LAKE SHAMINEAU LAKE IMPROVEMENT DISTRICT

**RESPONSES TO Agency and Public COMMENTS
on the EAW**

**In the matter of the Determination of
The Need for an Environmental
Impact Statement for the Lake Shamineau
High-Water Control Project**

**Lake Shamineau Lake Improvement District
Environmental Assessment Worksheet
Responses to Comments
Received February 24, 2020 through March 25, 2020**

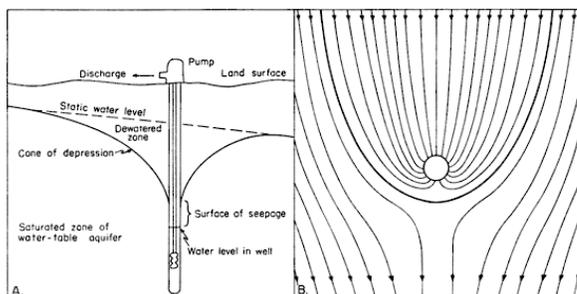
Comment 1) Reference to: EAW page 4 – groundwater mounding and the potential for groundwater to flow back to Lake Shamineau.

Summary Finding: The LSLID believes the groundwater mounding beneath the proposed infiltration basins will change the direction of groundwater flow around the basins and downgradient of the basins toward the downgradient surface waters. The regional gradient of the area indicates a strong northeasterly gradient from Lake Shamineau to Stanchfield Lake and so the mounding caused by the infiltration will not cause the water to flow back to Lake Shamineau. The effect of the mounding is similar to effect of a pumping withdrawal well, where the downgradient side of the pumping cone is much closer to the well than the upgradient portion of the cone (see figure below showing the flow paths for the pumping cone).

In the case of groundwater mounding, the effect is just the opposite with the upgradient side of the mound being much closer to the infiltration area than the downgradient side. Even if the groundwater mound rose to a level higher than Lake Shamineau, the groundwater flow moving east from Lake Shamineau will flow around the mound and follow the regional gradient to the east. In addition, the infiltration basins are far enough away from Lake Shamineau that the area between the groundwater mounding and the lake will have groundwater levels lower than Lake Shamineau. The proposed infiltration basins are nearly one mile from the lake with a wetland basin (locally called the ravine) located between Lake Shamineau and the proposed infiltration basins. This wetland basin would have to fill with 10 feet of water before the water level in the wetland would equal the water level of Lake Shamineau.

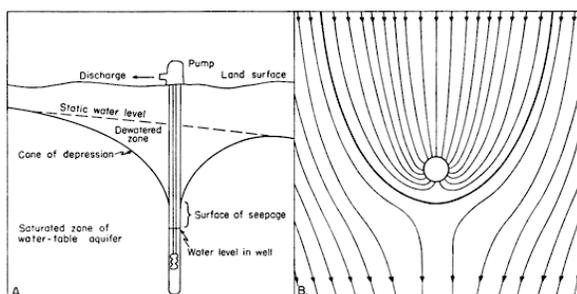
Groundwater Mounding

The regional gradient of area indicates a strong easterly gradient from Lake Shamineau to Stanchfield Lake and so the mounding caused by the infiltration will not cause the water to flow back to Lake Shamineau. The effect of the mounding is similar to effect of a pumping withdrawal well, where the downgradient side of the pumping cone is much closer to the well than the upgradient portion of the cone (see figure below showing the flow paths for the pumping cone).

In the case of groundwater mounding, the effect is just the opposite with the upgradient side of the mound being much closer to the infiltration area than the downgradient side. Even if the groundwater mound rose to a level higher than Lake Shamineau, the groundwater will flow around the mound and follow the regional gradient to the east. The infiltration basins are far enough away from Lake Shamineau that the area between the groundwater mounding and the lake will have groundwater levels lower than Lake Shamineau. The proposed infiltration basins are nearly one mile from the lake with a wetland basin (locally called the ravine) located between Lake Shamineau and the proposed infiltration basins. This wetland basin would have to fill with 10 feet of water before the water level in the wetland would equal the water level of Lake Shamineau.

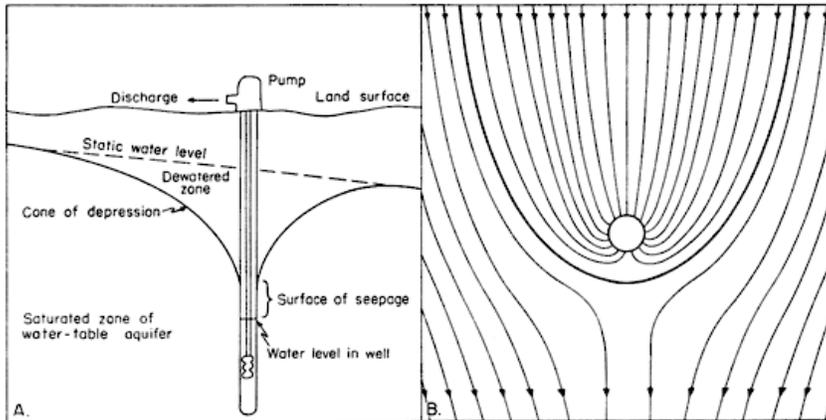
A. Site Evaluation

The project budget for the hydrogeologic investigation was limited and resulted in most of the work being completed at the gravel pit, where the infiltration basins were originally to be located. Because of the change to the current infiltration area and the need to get the EAW document completed, the cross-sections were not updated to reflect the improved information from the drilling of last fall and this winter. It was also intended that additional borings would be completed prior to permitting. DNR should know that Unique Well Numbers 528964 and 769083 are not DNR observation wells, but are a private residential well and a private irrigation well, respectively. The reference to mottling at 35 feet below the surface in the new boring (NS-B3) does not necessarily mean that there are consistently saturated conditions at that depth and, in fact, the groundwater level seen in the boring is deeper.

The project's soil borings and observation wells indicate no clay layer in any of the logs with many near Unique Well Number 528964. This is indicative that the water well drillers had mis-identified the near surface soils as clay in the well record for the residential well. The DNR references a groundwater level of 1278 feet in elevation observed in a boring located 700 feet south of the proposed infiltration basin, but provide no boring log or figure showing the location of this boring so it is unclear what significance this has regarding the water level information provided in the EAW.

The summary made in the Hydrogeologic Investigation Report is based on both the data and geologic interpretation of the data. The assumption that the finer textured material in PZ-3 was a small sliver extending into that area was born out by the test boring in the proposed infiltration basin area, as it found no clay, but sands and gravels down to 130 below the surface. The reference to the nearest DNR observation well is in error as the nearest DNR observation well is over two miles away. More geologic data in the area of and downgradient of the infiltration basins would be useful, but the limited budget made obtaining more data problematic. The LSLID board planned on acquiring more of this data during the permitting process.
